CITY OF KEY WEST

ADDENDUM NO. 1 CAROLINE STREET IMPROVEMENTS / ITB 15-007

This addendum is issued as supplemental information to the bid package for clarification or amending of certain matters of both a general and a technical nature. The referenced Invitation to Bid (ITB) package is hereby addended in accordance with the following items:

PARTIAL SITE LIGHTING PLAN
SCALE: 1"=20'

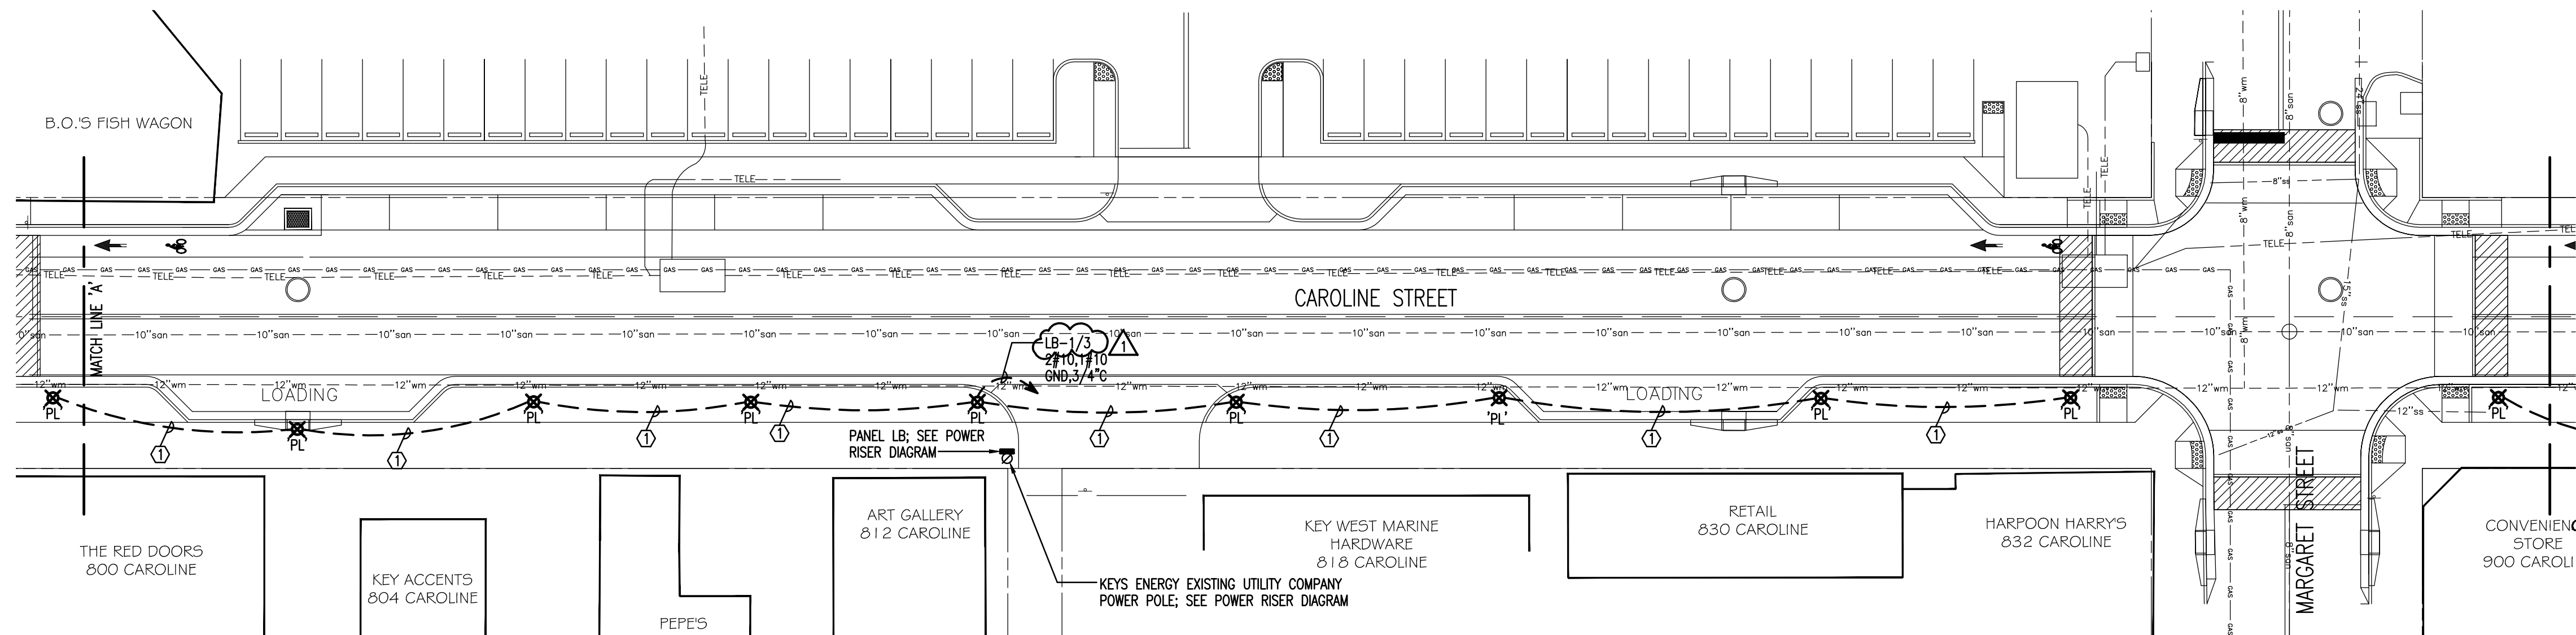
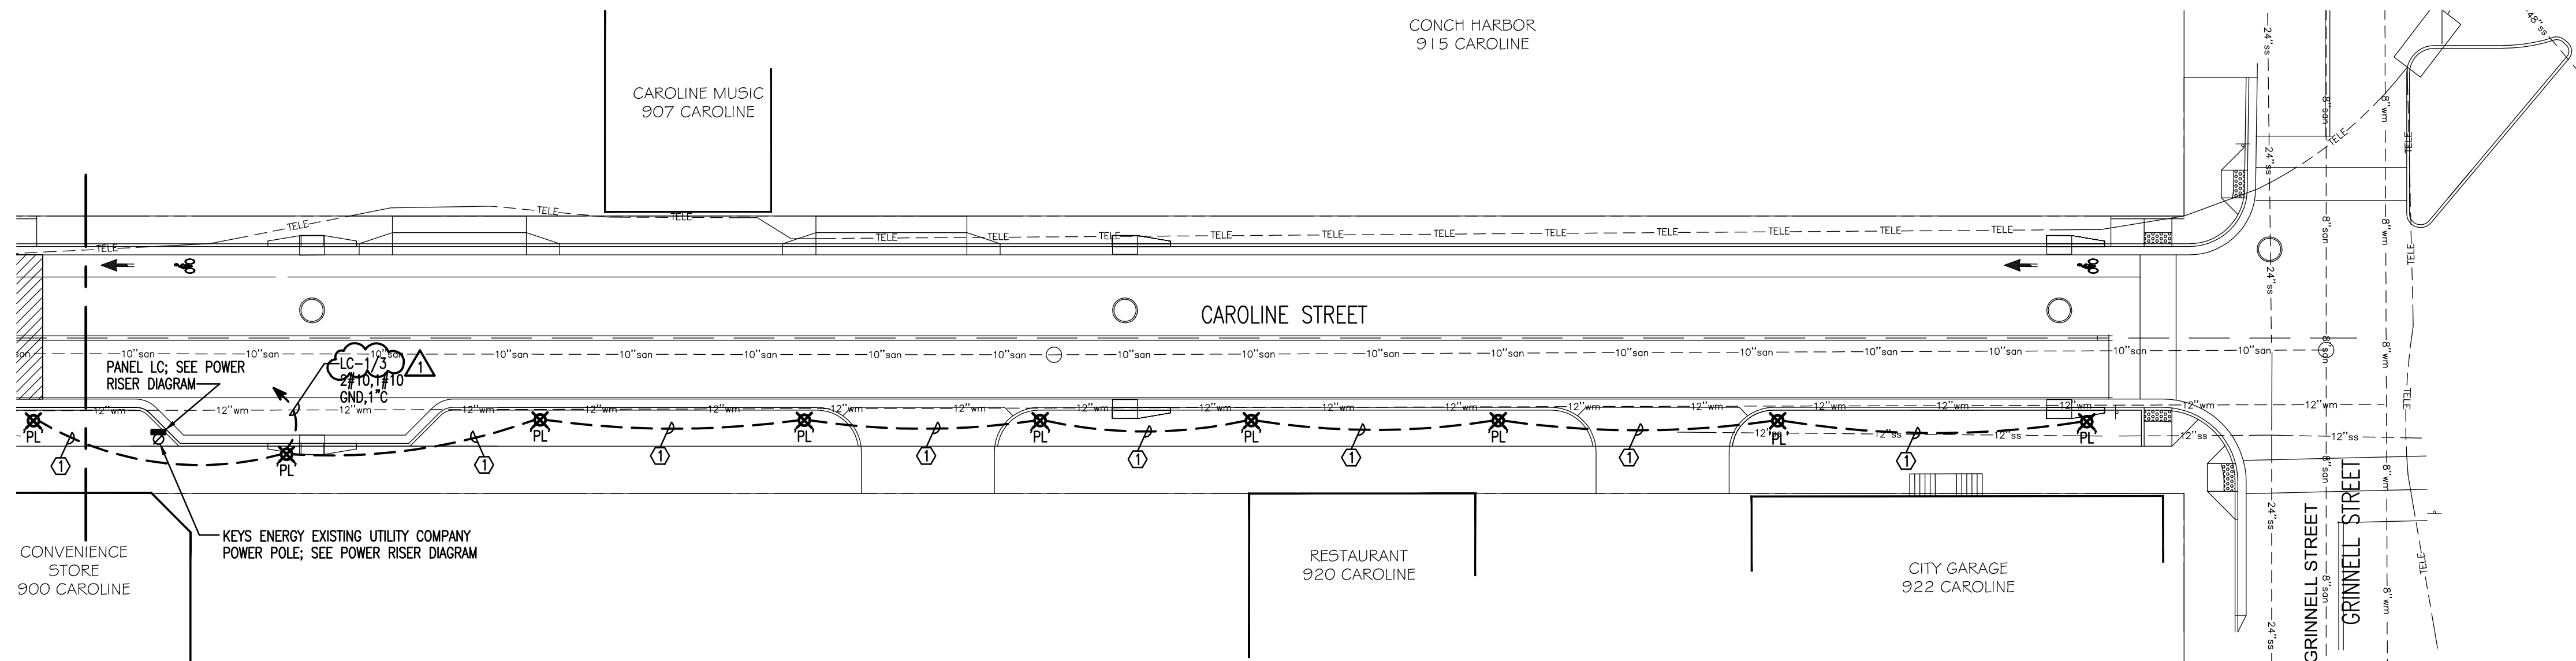
<u>Sheet(s)</u>	<u>Description</u>
E-2	LIGHTING PLAN – Corrected “Key Note” to revise lighting circuits to be 2-pole.
C-5	ROADWAY – Lengthened loading zone at approximately STA 8+45 to 72 feet
C-9	DRAINAGE PLAN AND PROFILE – Provided clarification of grading for Parking Garage ramp at approximately STA 13+28
C-10	SIGNING AND PAVEMENT MARKING PLAN – Revision of Loading Zone and Parking Space signage and striping locations and details
C-11	SIGNING AND PAVEMENT MARKING PLAN – Revision of Loading Zone and Parking Space signage and striping locations and details
C-19	PARKING LOT PLAN – Revision to add two (2) pedestrian access/egress points along proposed fence line, 5 feet wide each with steps as applicable.

- ① 2#10,1#10 GND, 3/4"
